**DOCUMENT 00 90 00  
ADDENDUM**

**ADDENDUM NO. [4]                      Date: November 21, 2018**

**RE:                      GLENWOOD COMMUNITY SCHOOL DISTRICT  
ATHLETIC COMPLEX IMPROVEMENTS BID PACKAGE 2 REBID  
400 SIVERS ROAD  
GLENWOOD, IOWA 51534  
HSR PROJECT NO. 18005**

**FROM:                  HSR Associates, Inc  
100 Milwaukee Street  
La Crosse, WI 54603  
(608) 784-1830**

**E001R**

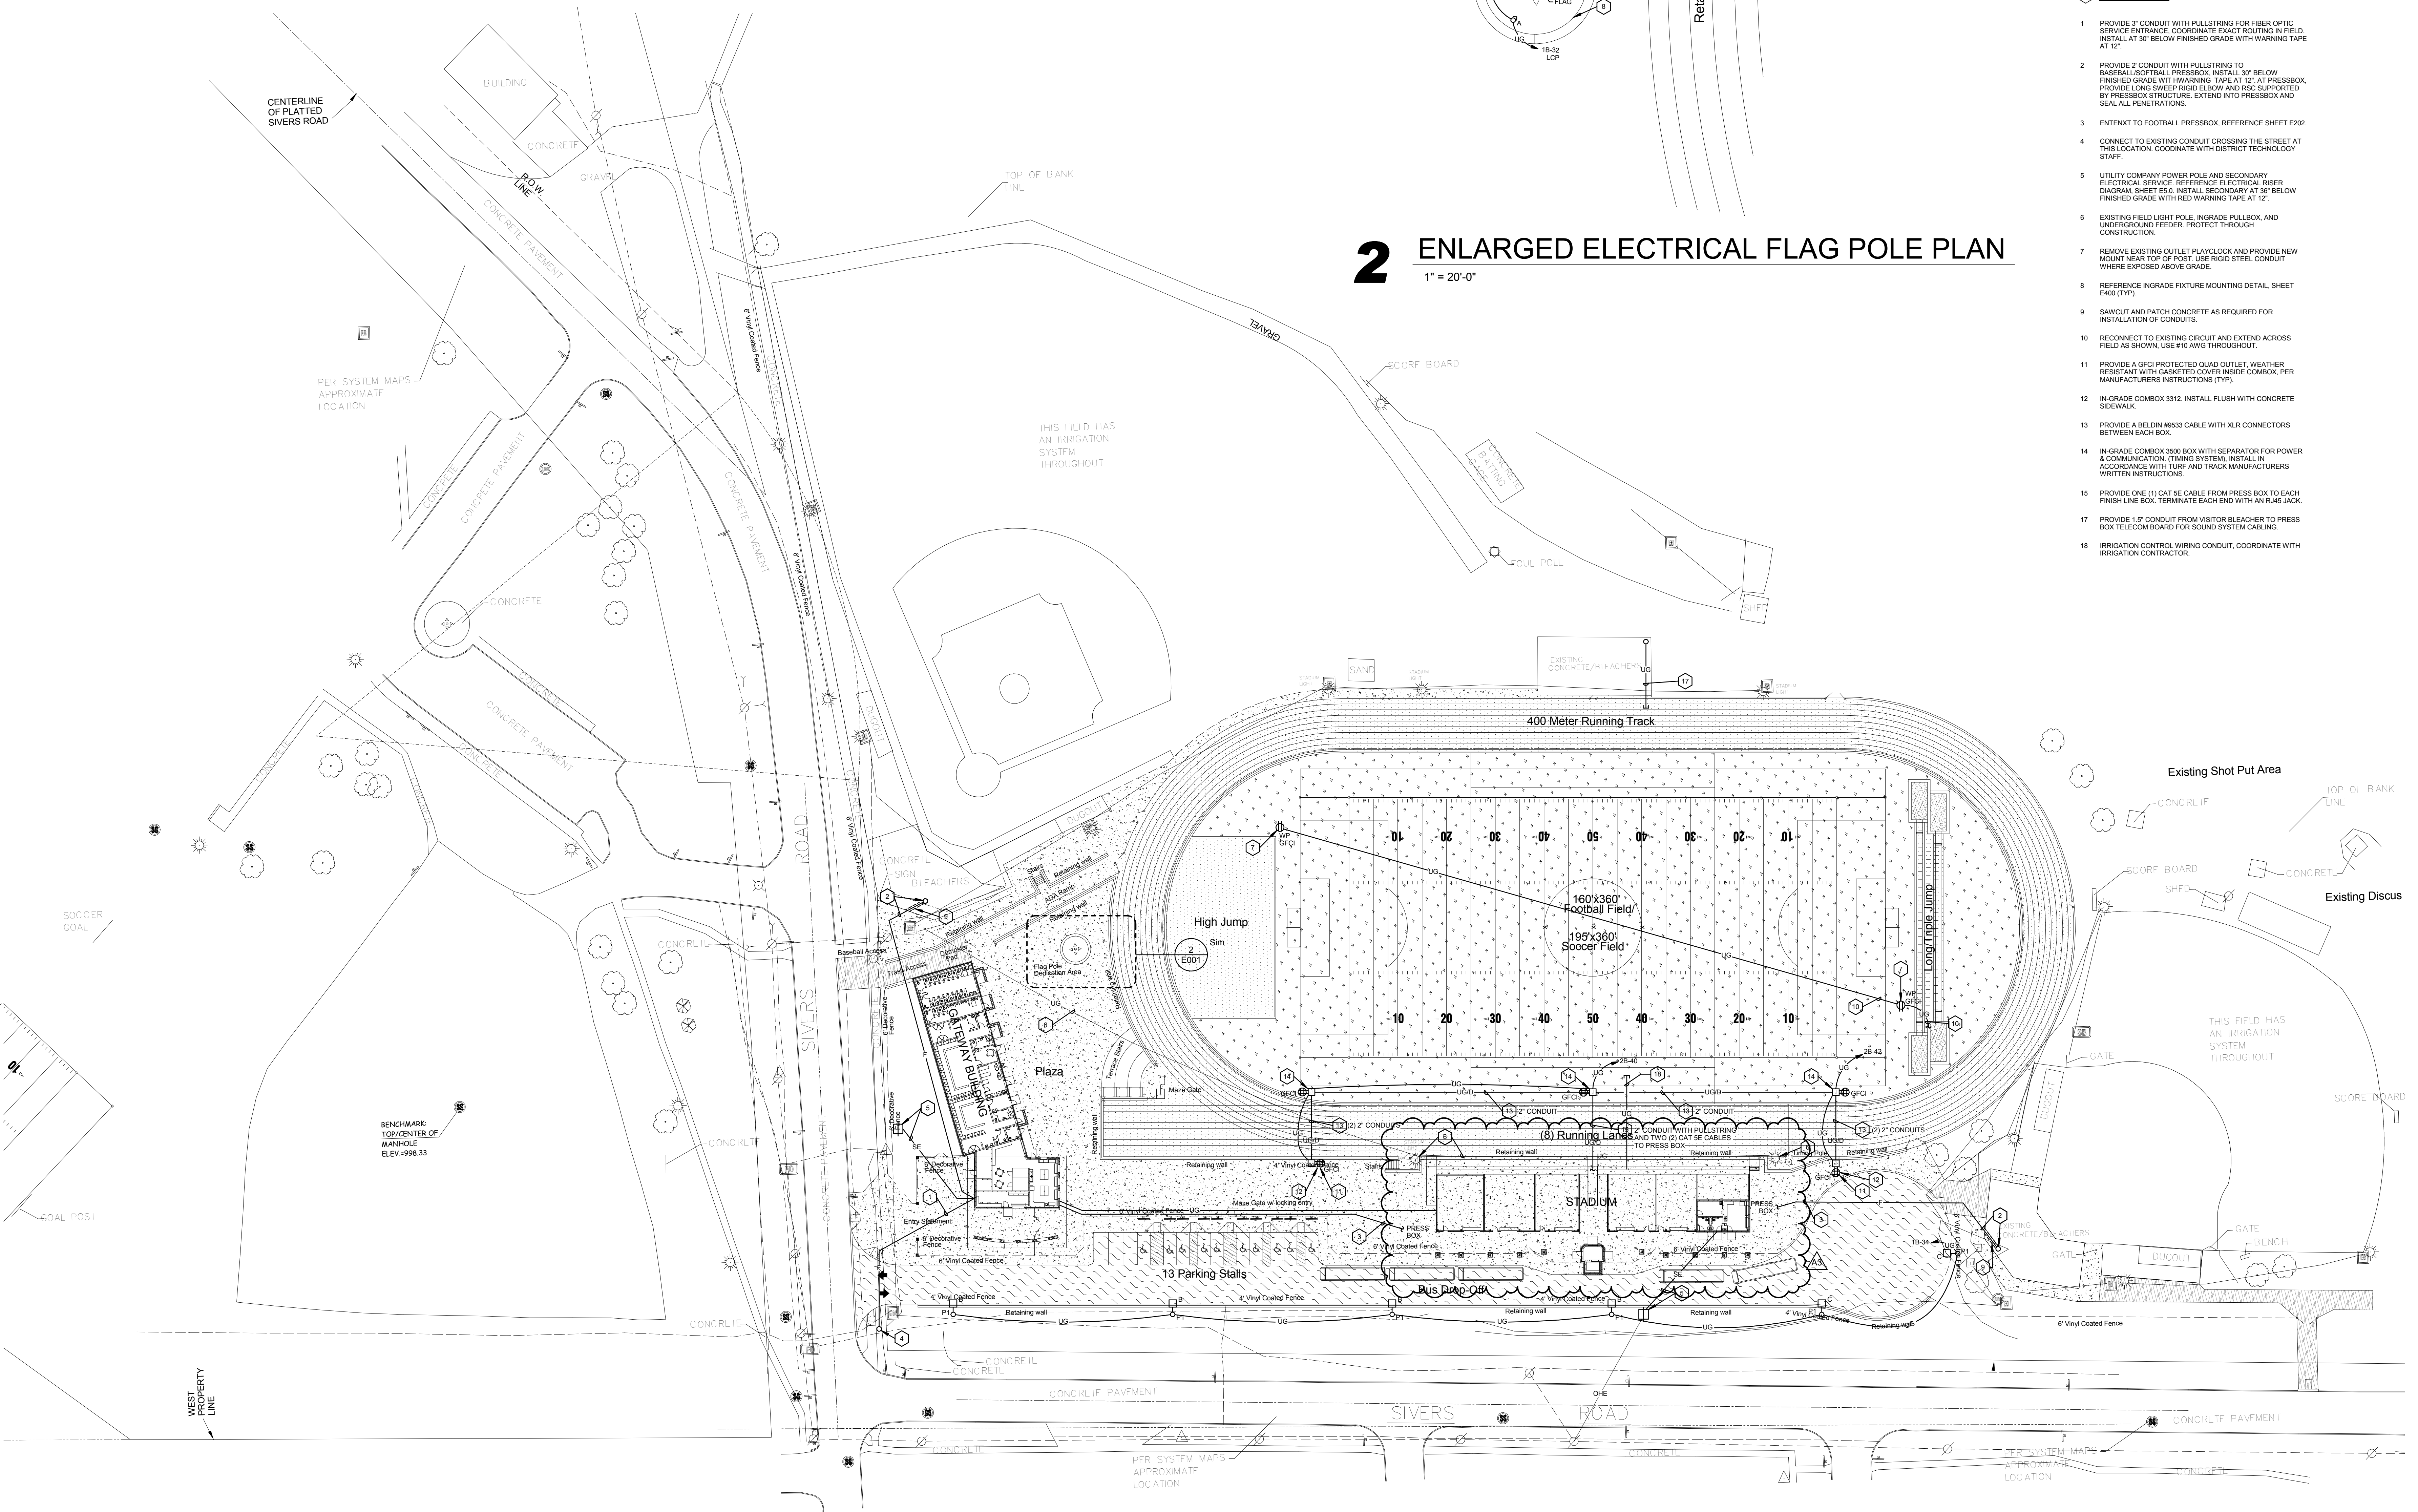
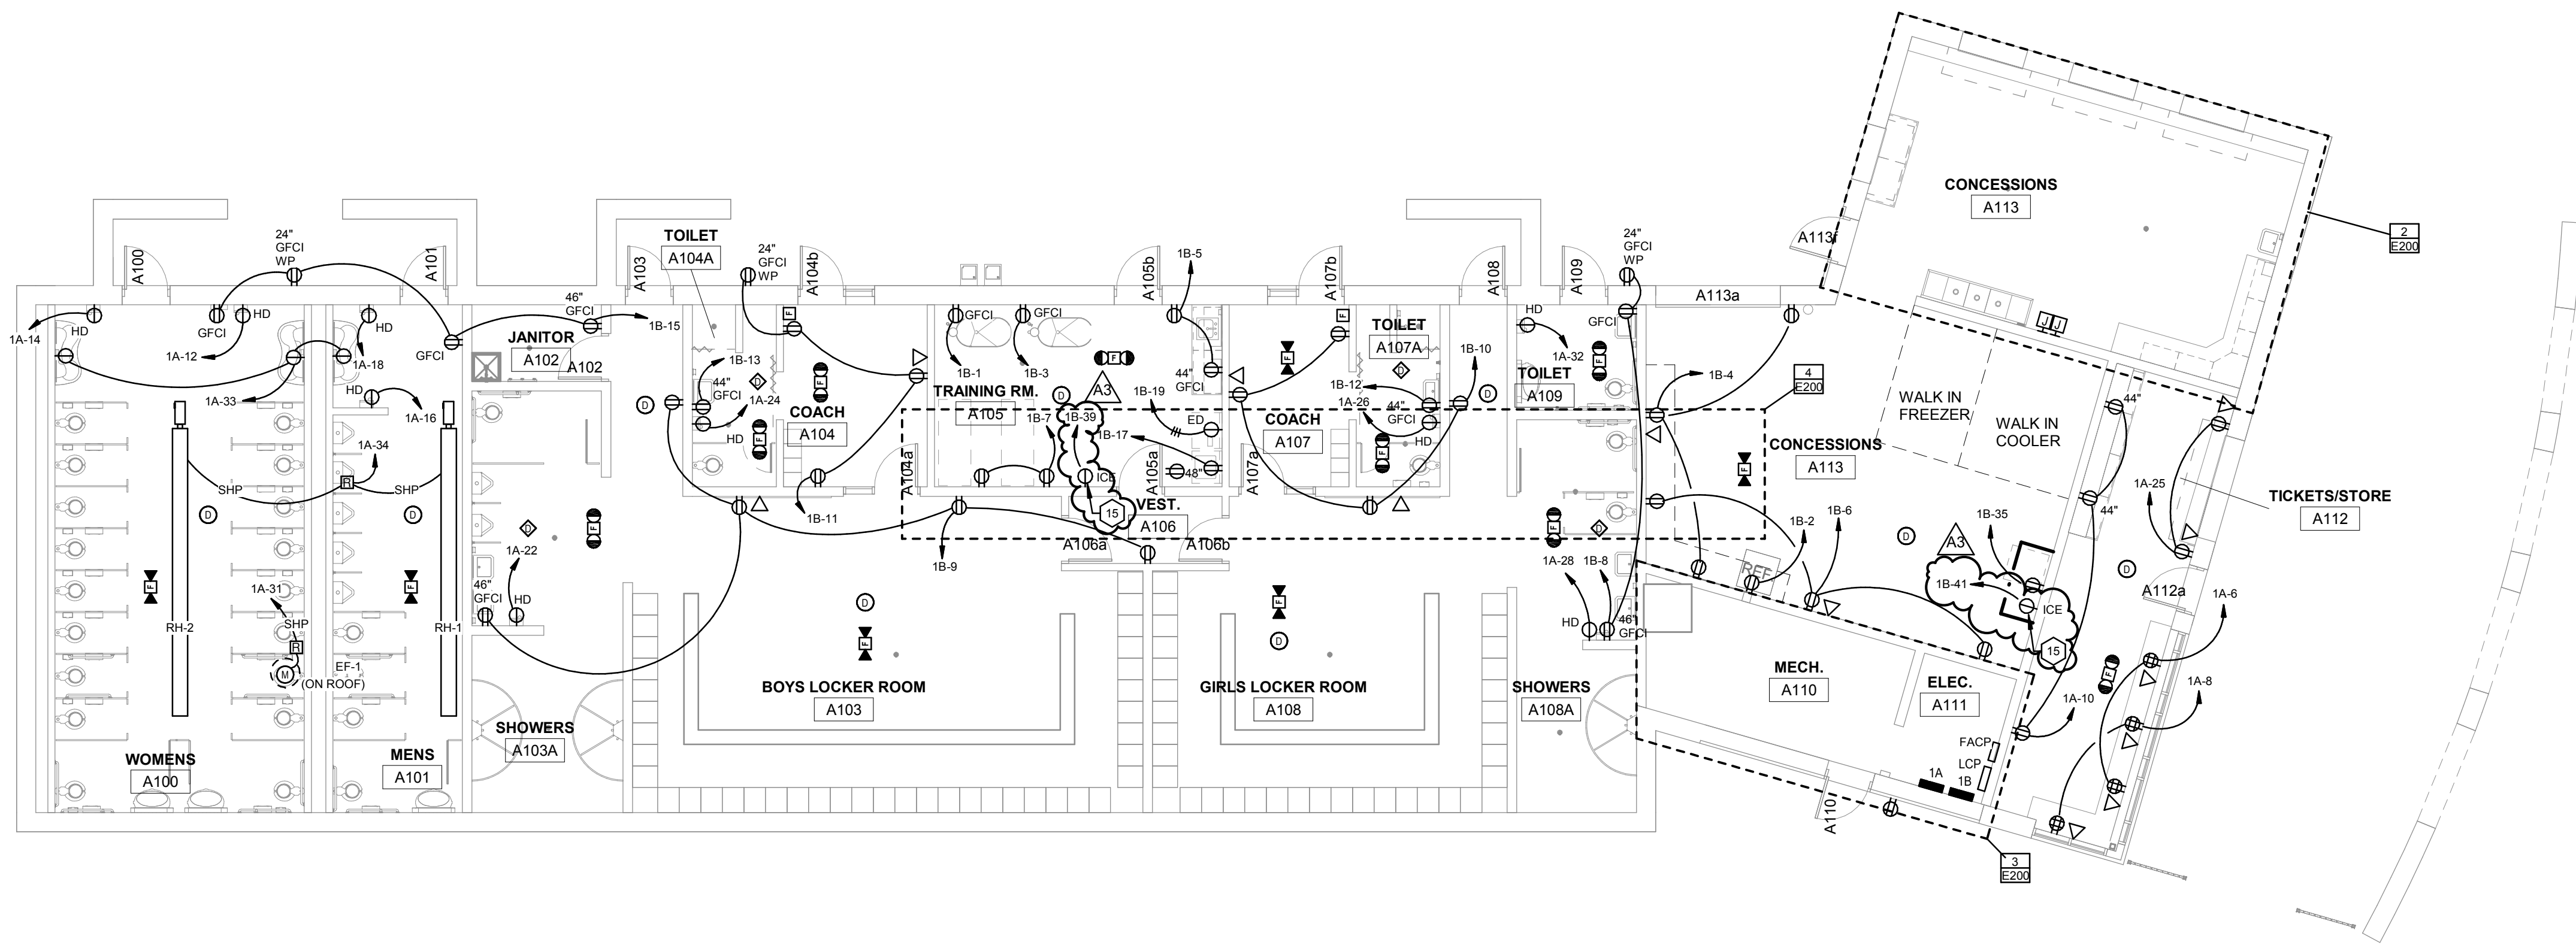
9. Sheet E001R ELECTRICAL SITE PLAN 30 x 42 attached hereto.
- a. Revisions clouded on Drawing
  - b. Background has been updated.
10. Sheet E200R GATEWAY BUILDING POWER PLAN 30 x 42 attached hereto.

**E200R**

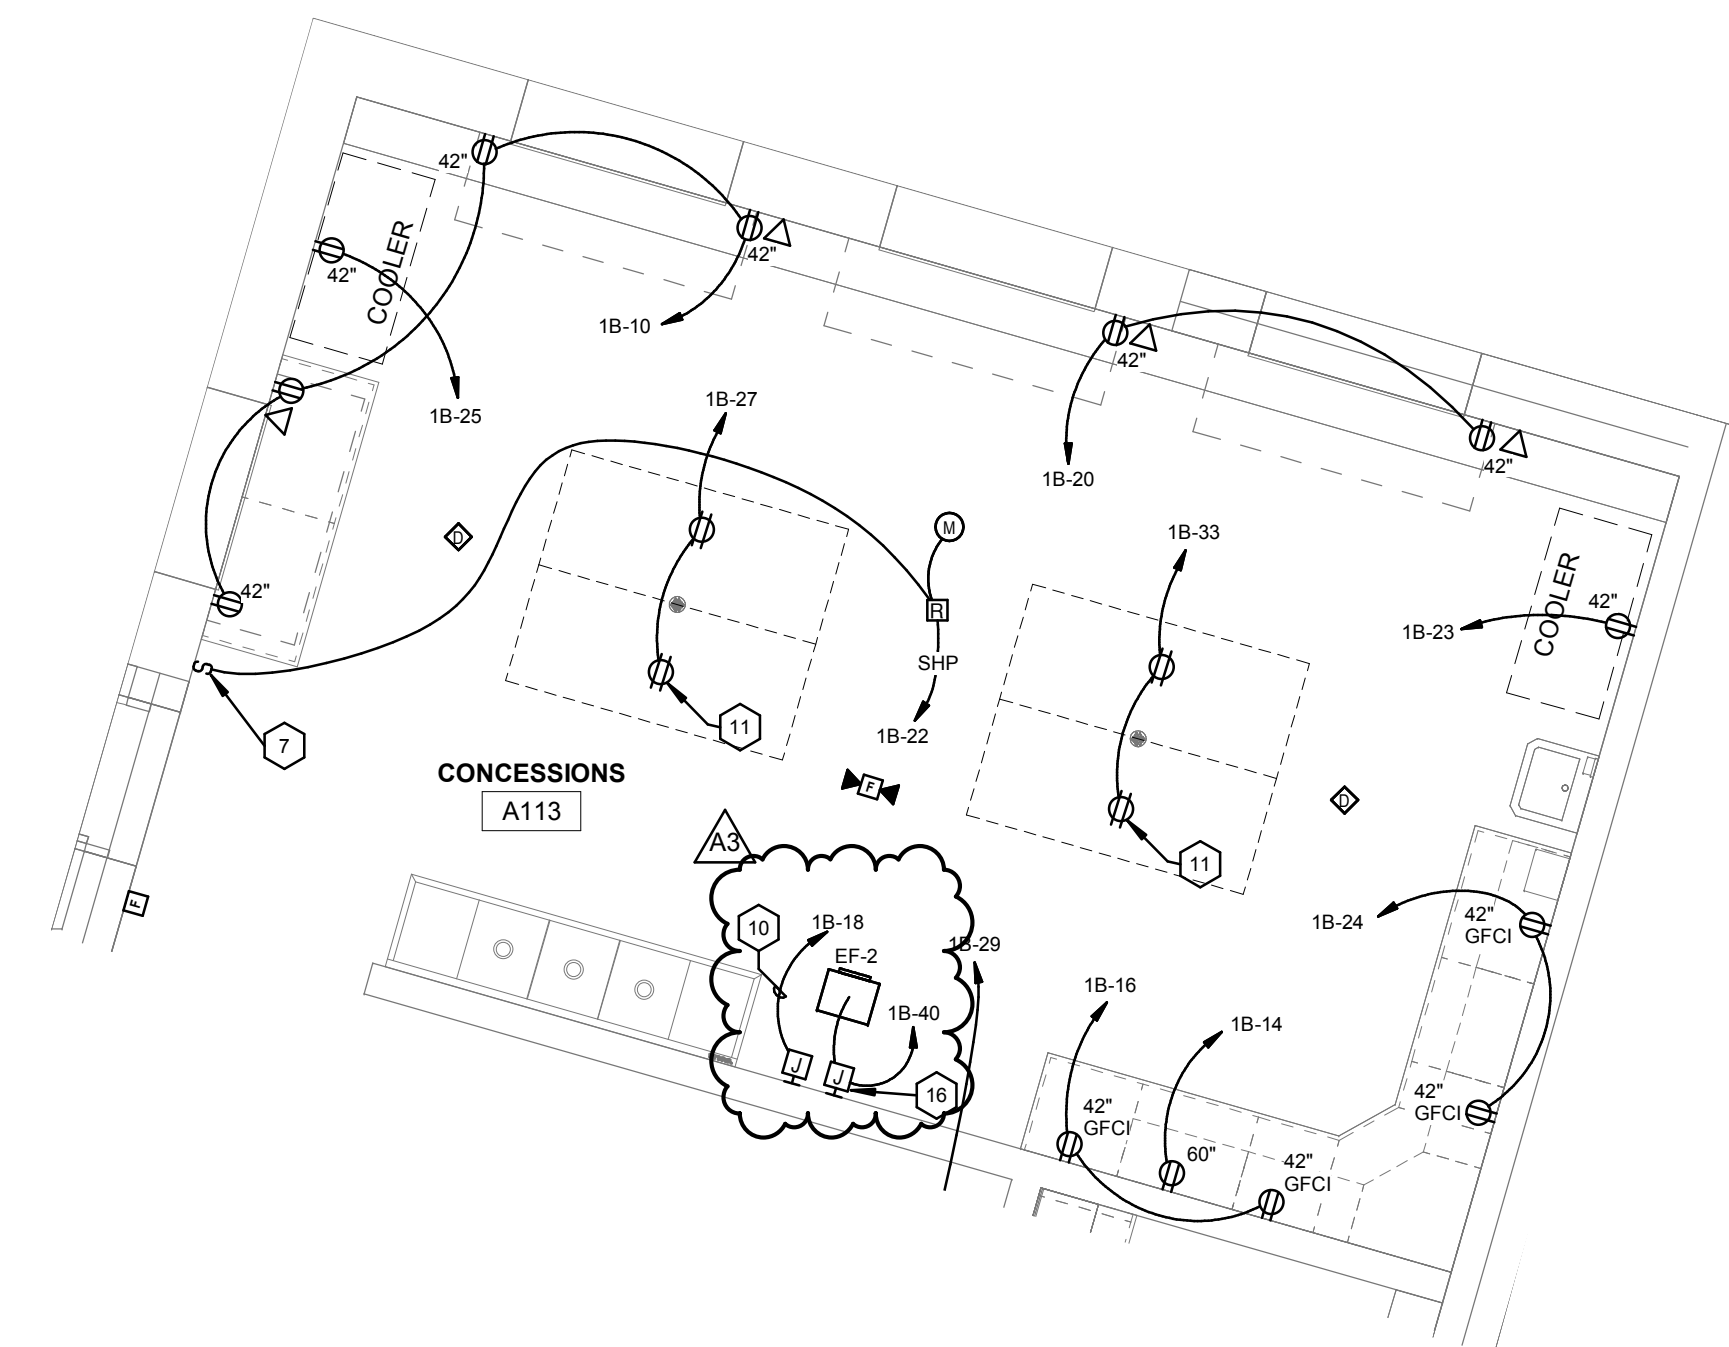
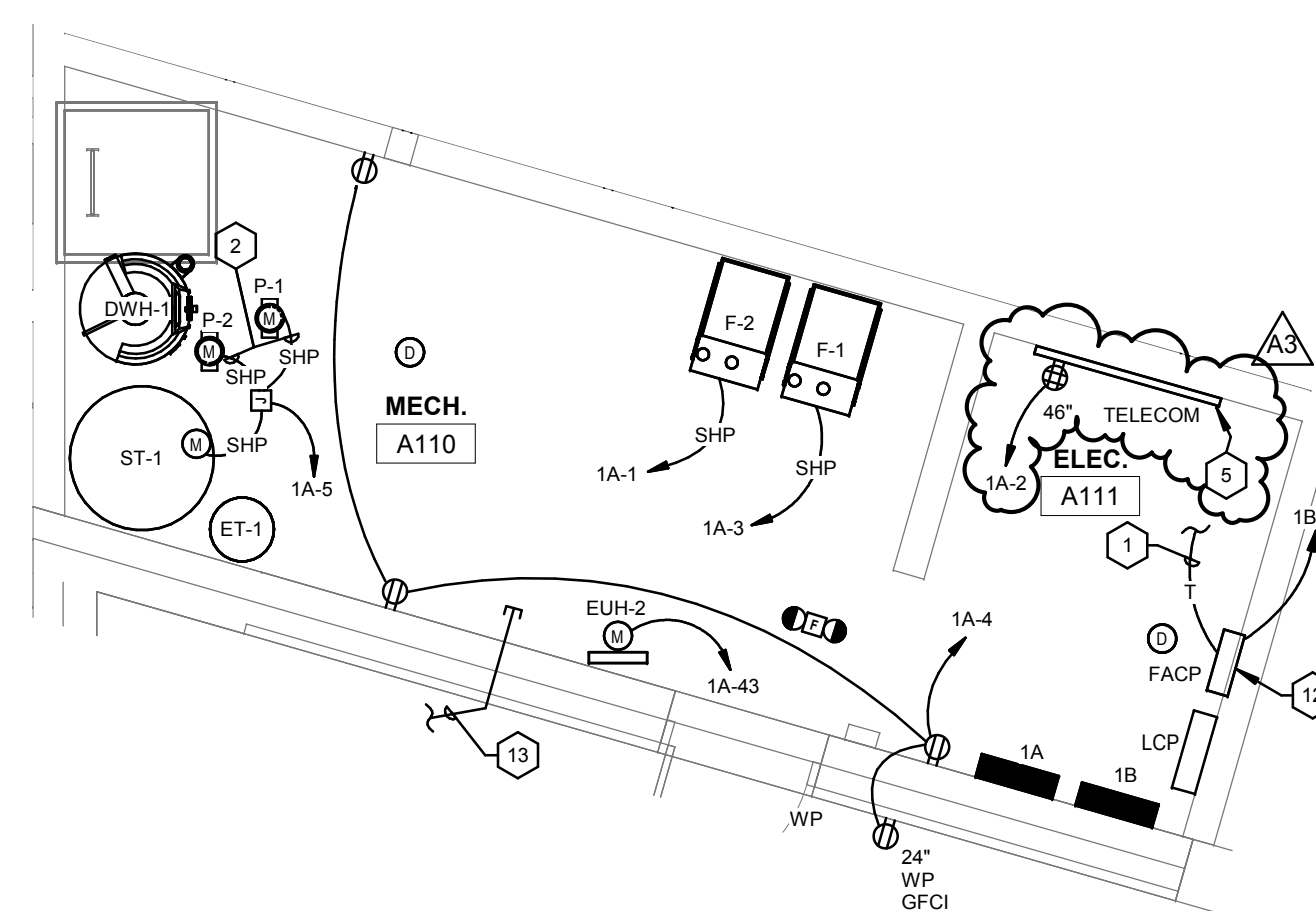
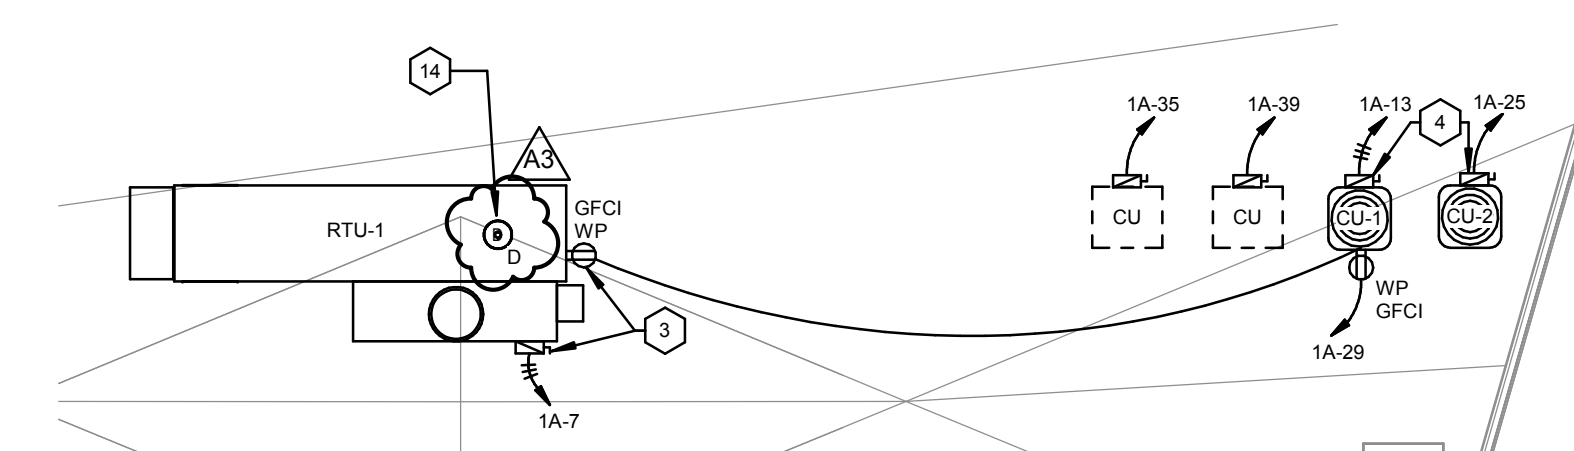
- a. Revisions clouded on Drawing
  - b. Moved telecom board in MECH A110 room.
  - c. Duct smoke detector and note added to RTU-1 on Electrical Roof Plan.

- d. Ice machine removed from Concessions Enlarged Power Plan – two ice machine locations added to First Floor Power Plan.
  - e. Receptacle changed to wall-mounted Junction Box on Concessions Enlarged Power Plan.

- f. Wall Mounted Junction box added for Speed Controller for EF-2 on Concessions Enlarged Power Plan.
  - g. Notes added for new ice machine locations and wall mounted Speed Controller for EF-2.
